ADDENDUM #01

TO CONTRACT DOCUMENTS FOR: PROJECT #CP250051 – Agriculture Engineering Building – Rms 164/166 Fermentation Lab Renovation

PREPARED FOR: The Curators of the University of Missouri

CONSULTANT: Planning, Design & Construction
University of Missouri
130 General Services Building
(573) 882-6800

B1

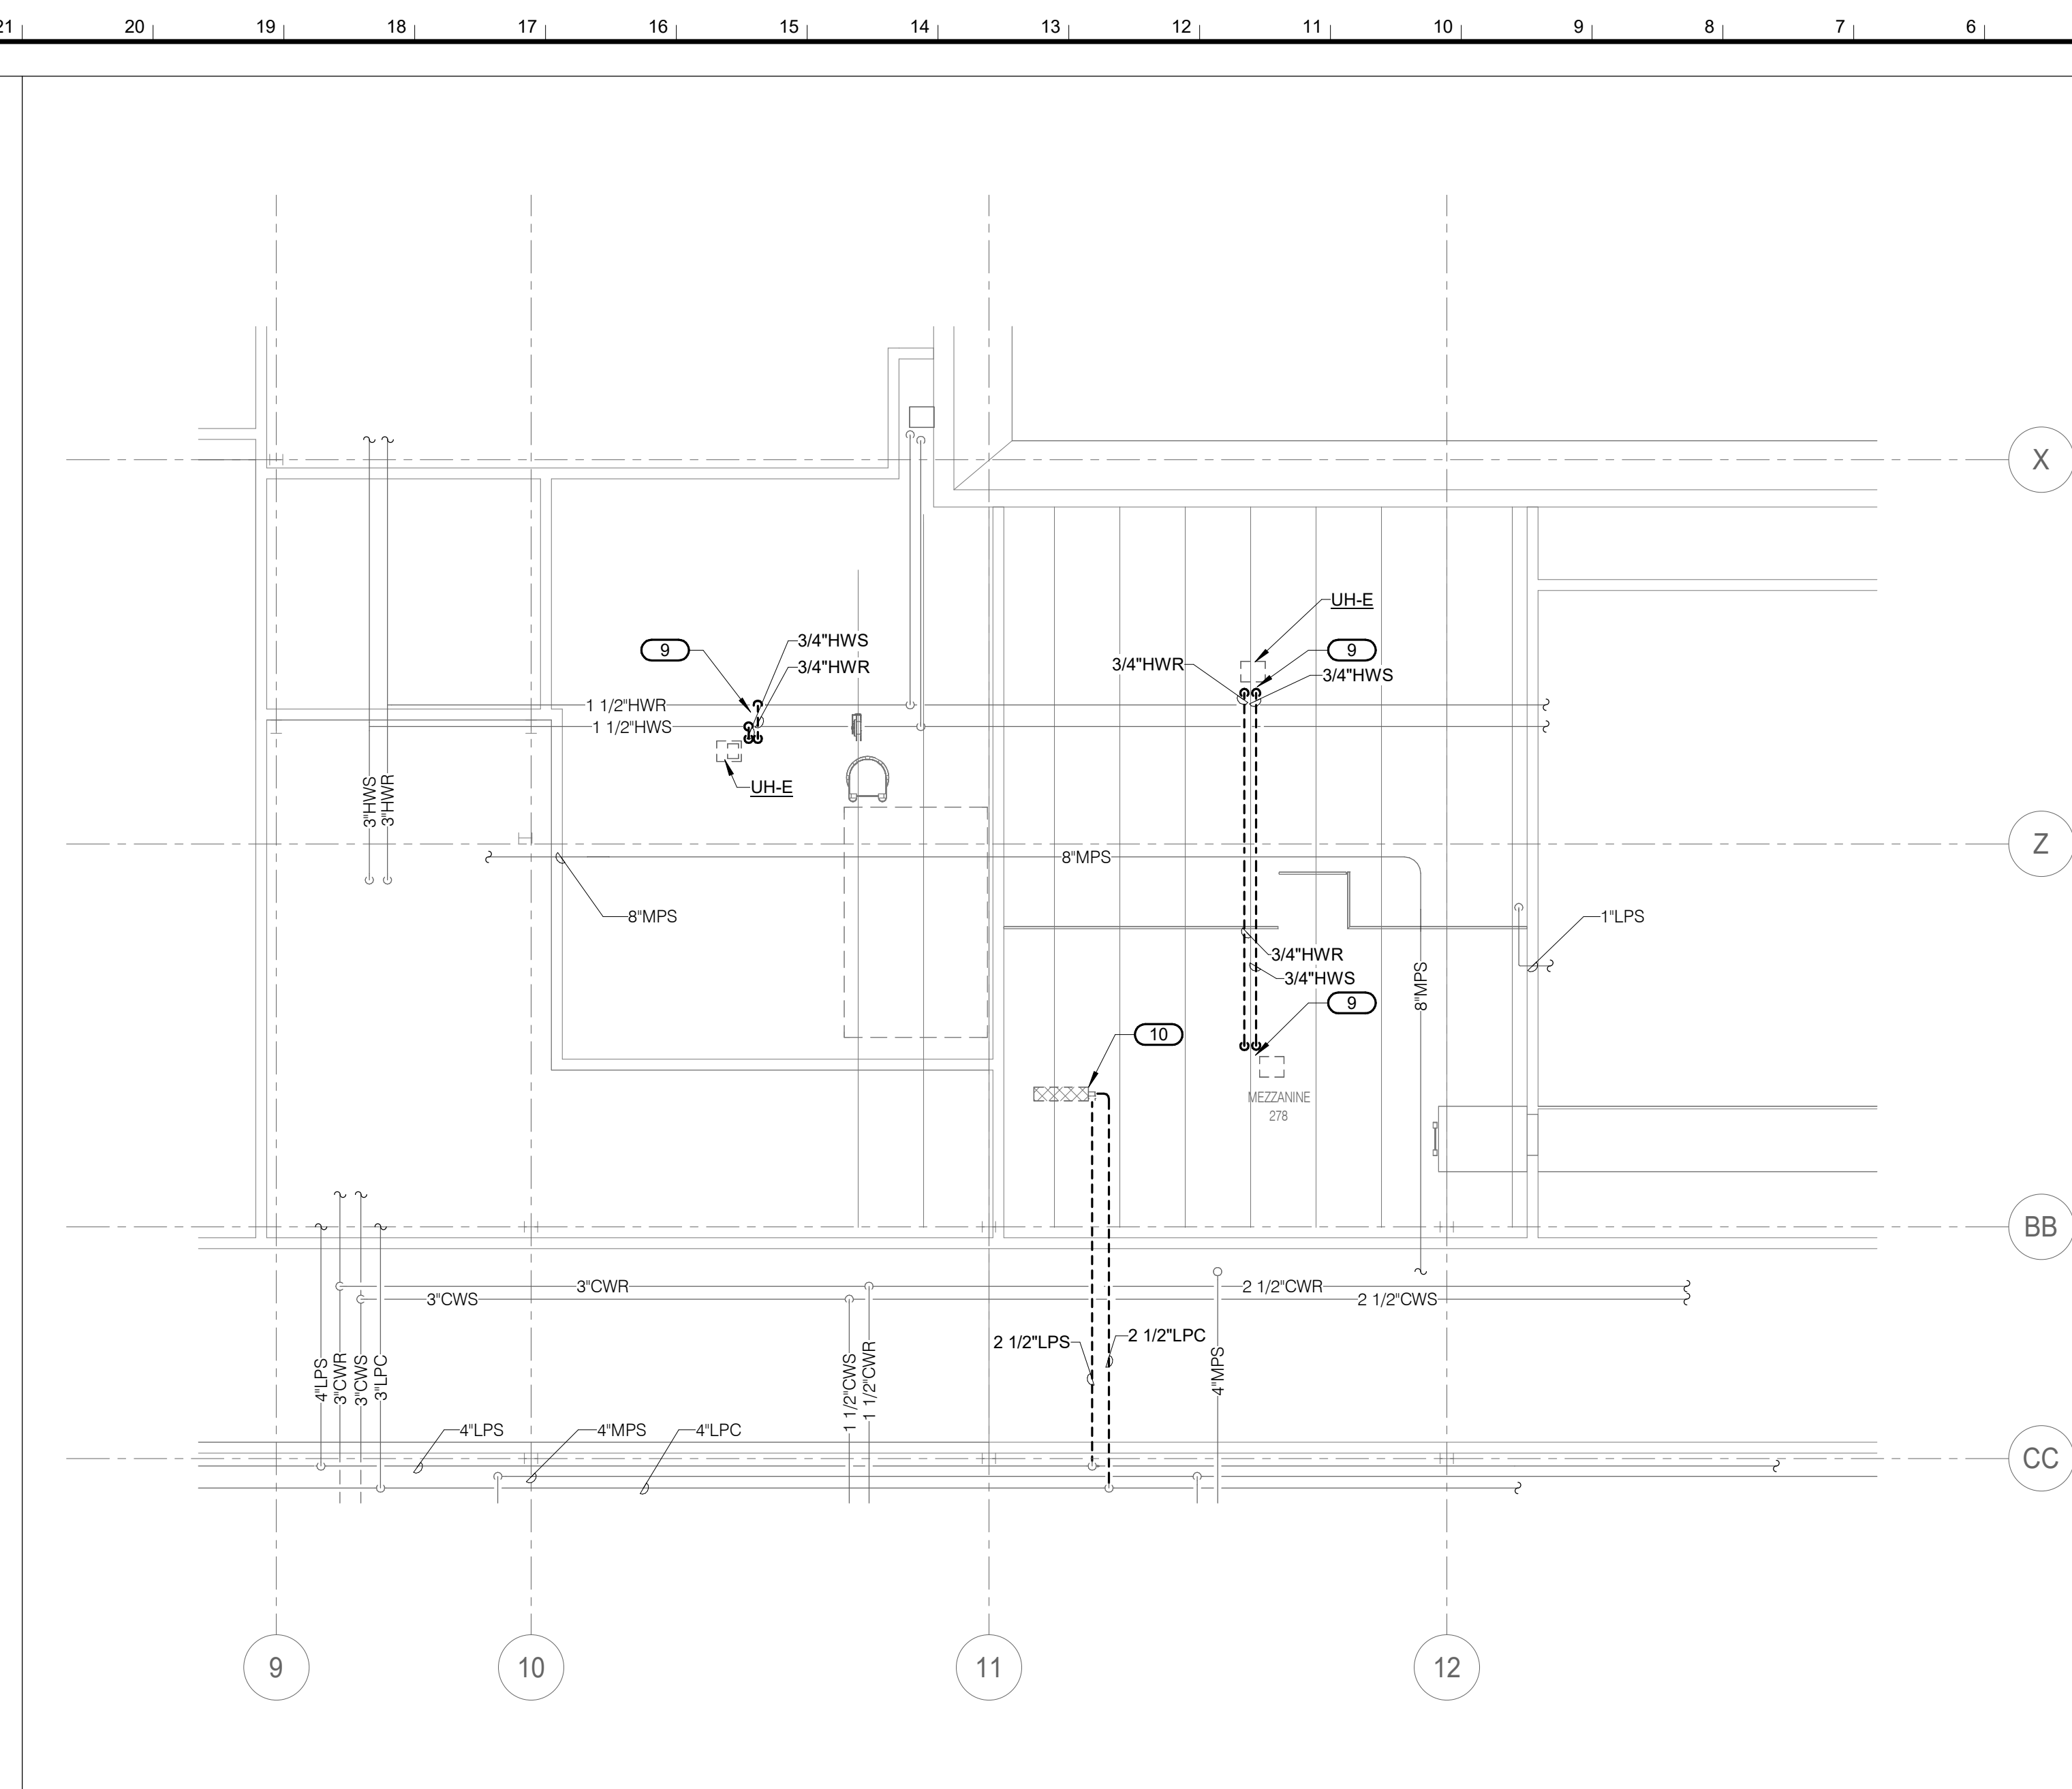
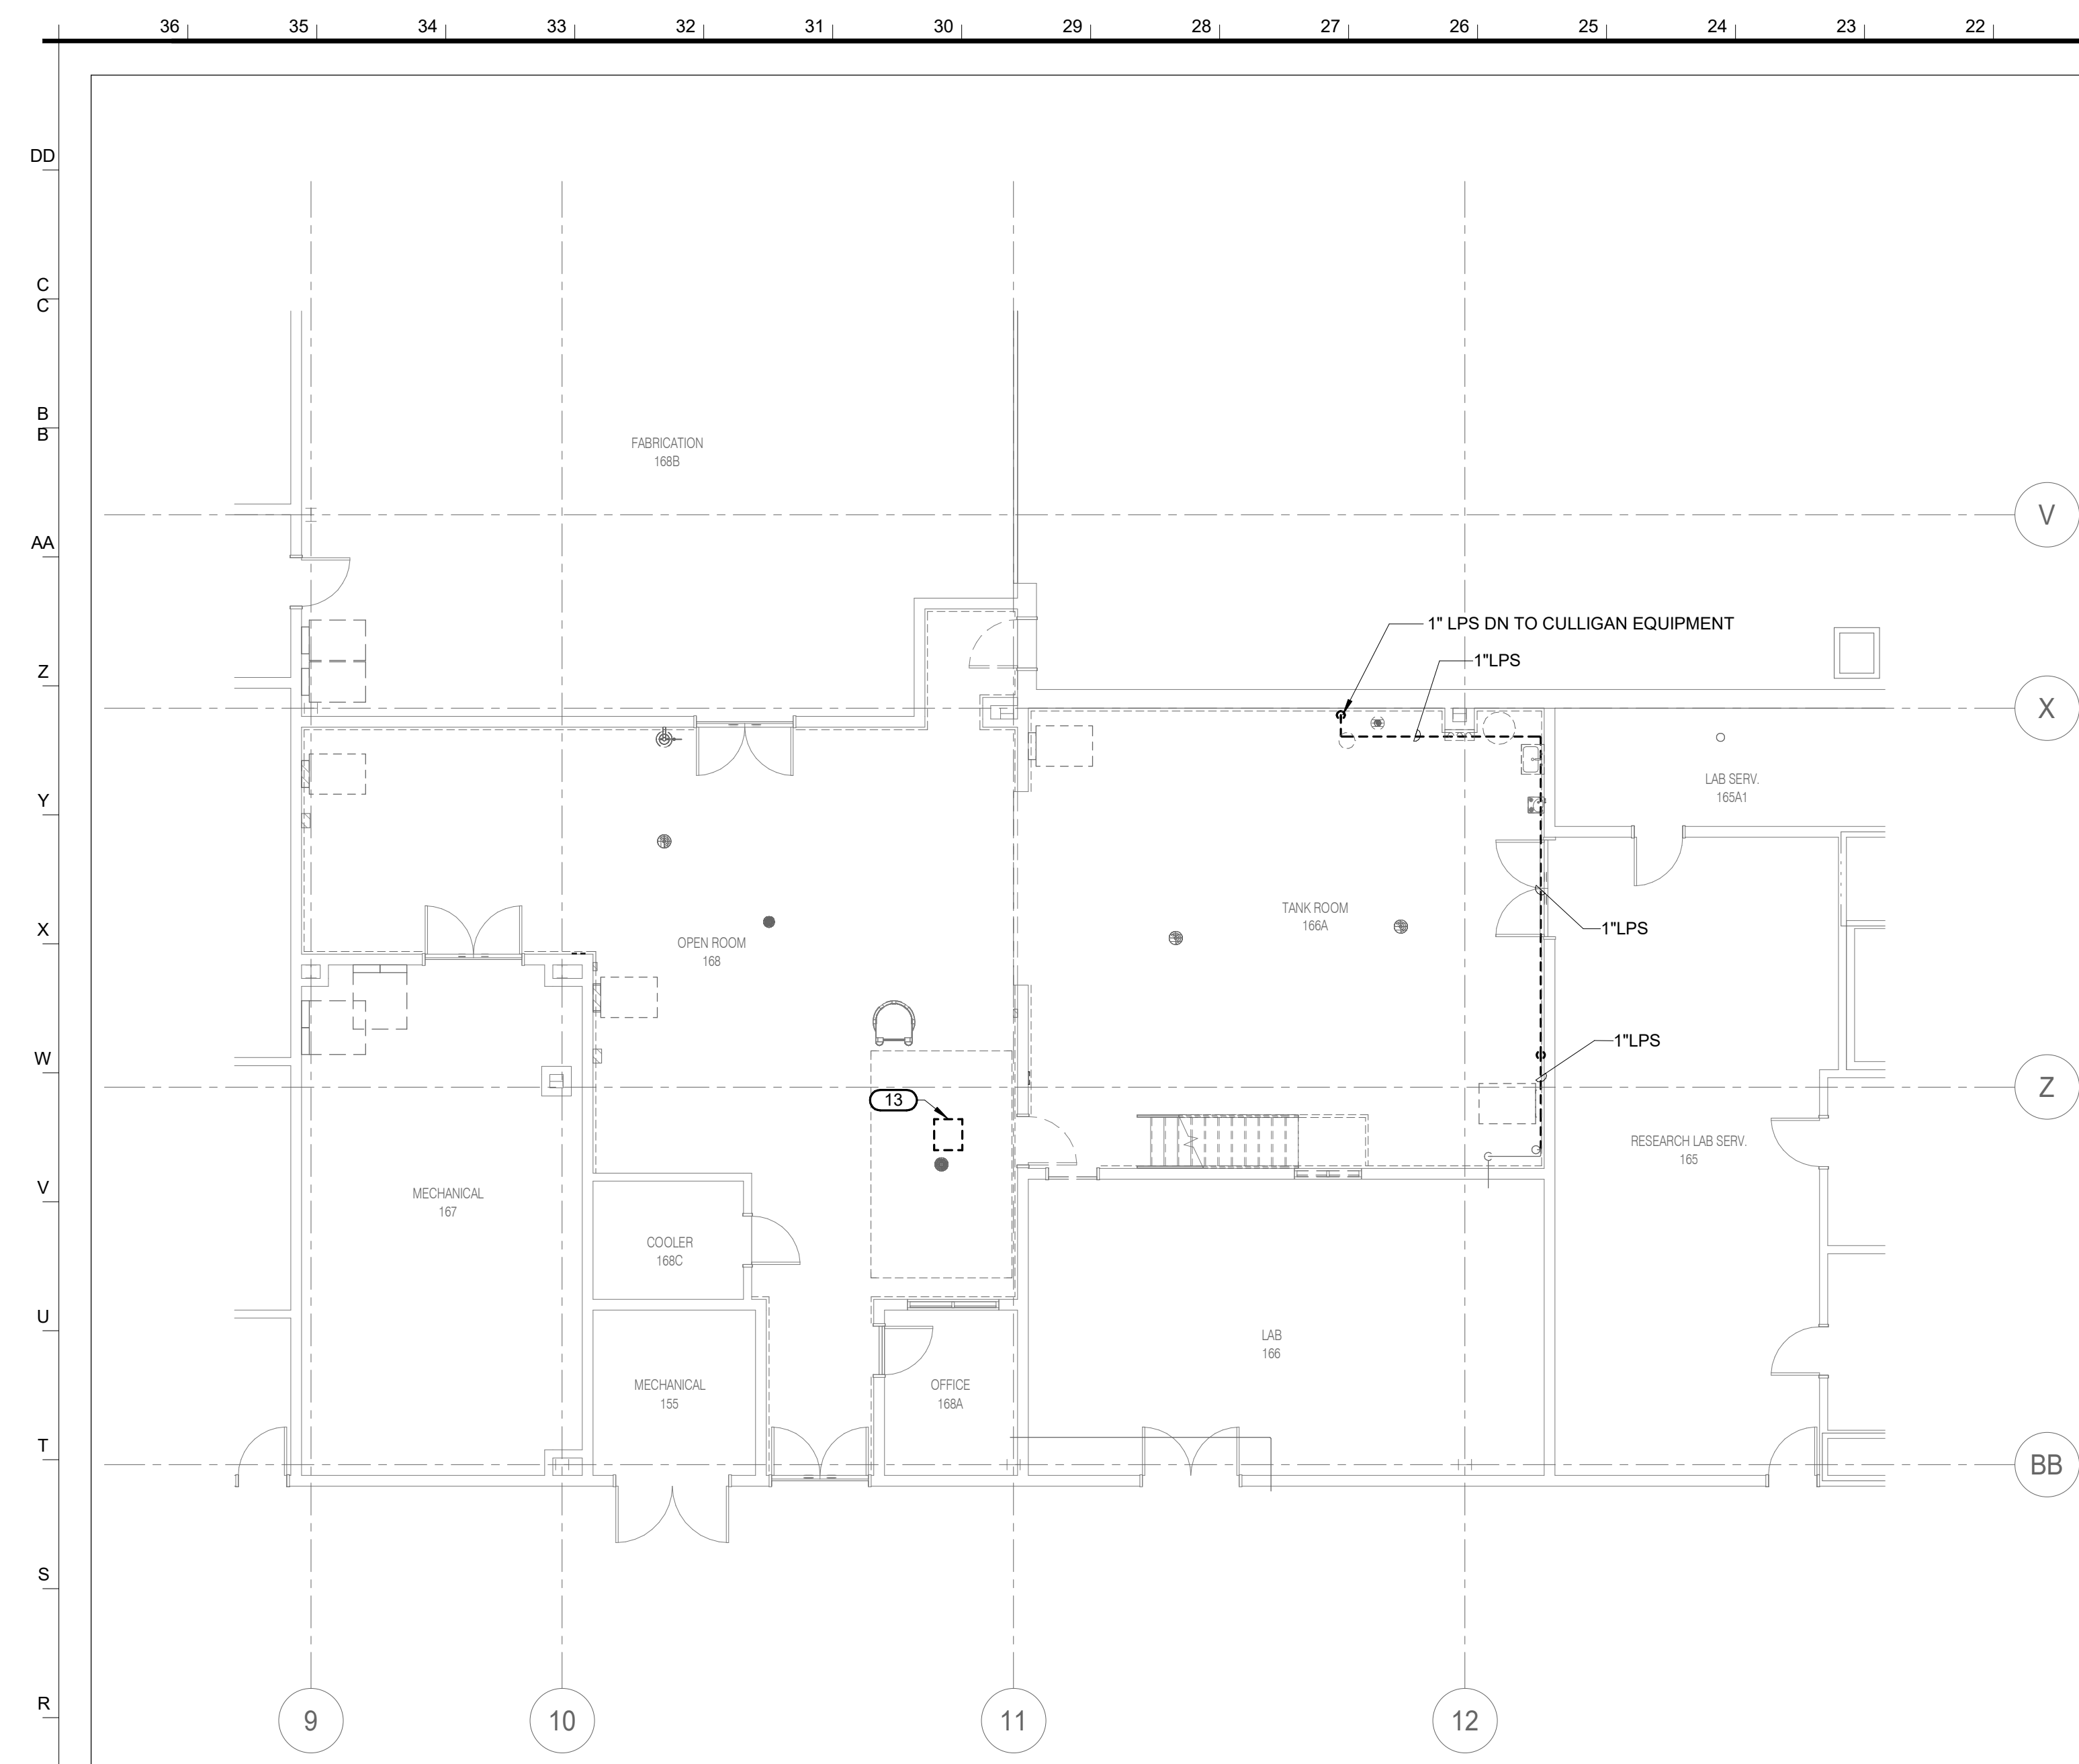
CLARIFICATION: Keynote 4 revised for contractor to coordinate with owner on flexible piping requirements.
Keynote 5 revised to indicate piping connections to be above accessible ceiling.
New Keynote 13.
Demo Unit Heater equipment and note added in Room 168.
